Subject: Leachate Reintroduction to Sanitary Sewer Plan

BFI Waste Systems of New Jersey, Inc.
Spotswood-Gravel Hill Road
Monroe Township
Middlesex County, NJ

Response to Jacobs Engineering Comments

Response to EPA Comments

FIGURE 1 - SITE PLAN

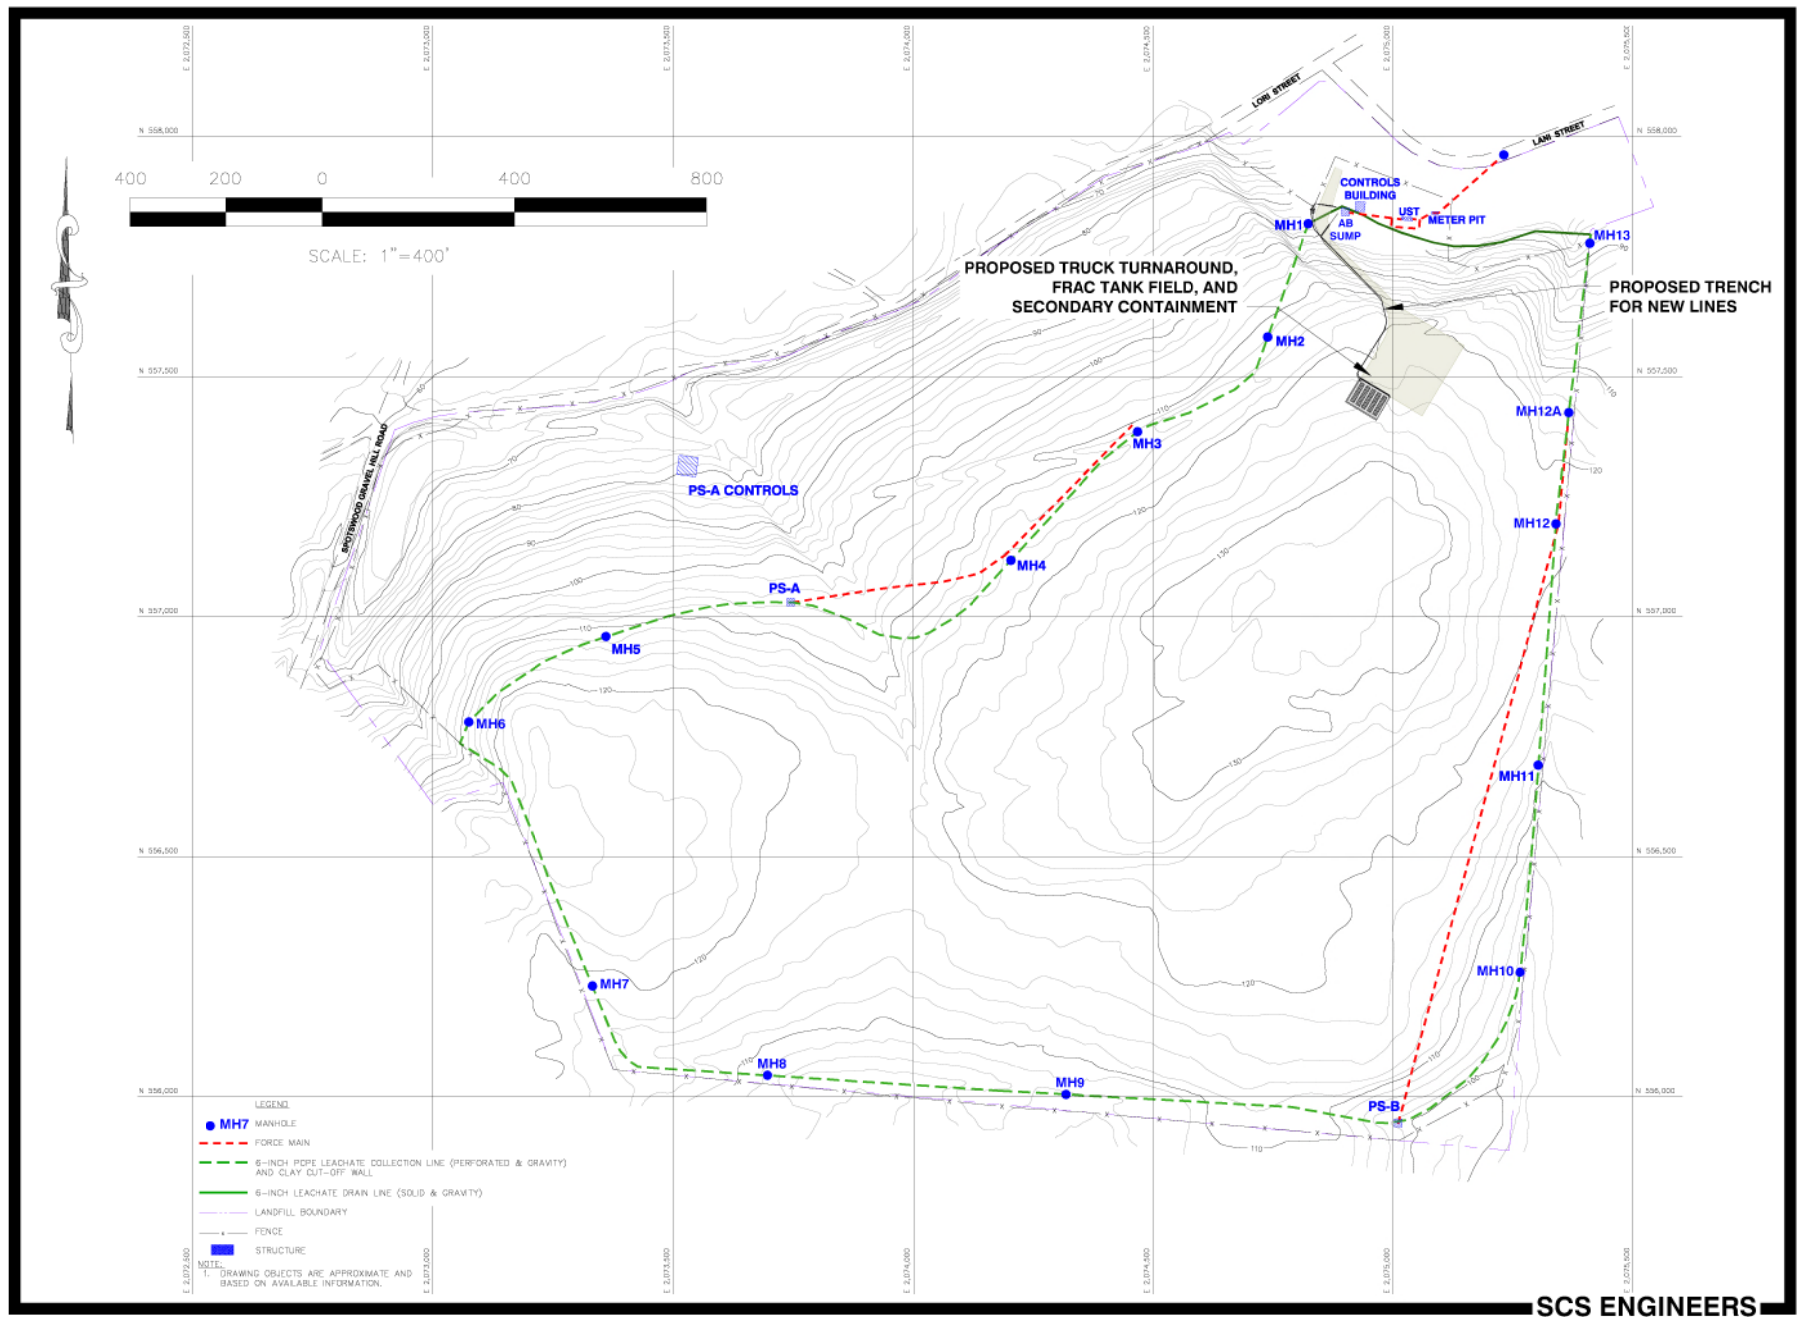
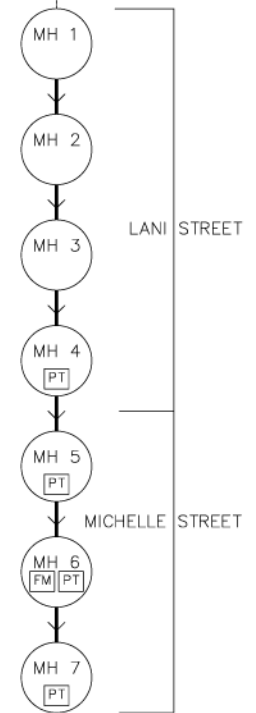
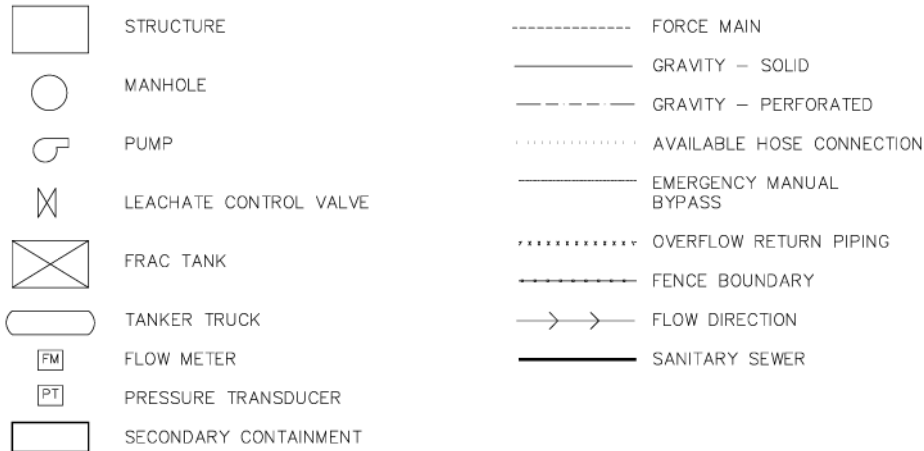
Schematic diagrams of the landfill leachate collection system along with a description of how it is operated needs to be included. The description should show the configuration of pumps and controls at the time of the initial odor issues and then the current configuration and the added controls. Details such as where the new variable-speed pump(s), flow monitoring equipment, and gravity feed sections of pipe are located should be included. The remote monitoring and control system capabilities should explain when and how alarms will be transmitted, who will receive such alarms and what will be done to respond. If there are automatic controls, they should also be explained.

Refer to the attached Figure 1 for a site plan detailing the gravity and force main systems, as well as locations of the various manholes, pump stations, and holding tanks. Also attached are two process and instrumentation diagrams (PID) for the existing and proposed system configurations referenced in the discussion below.
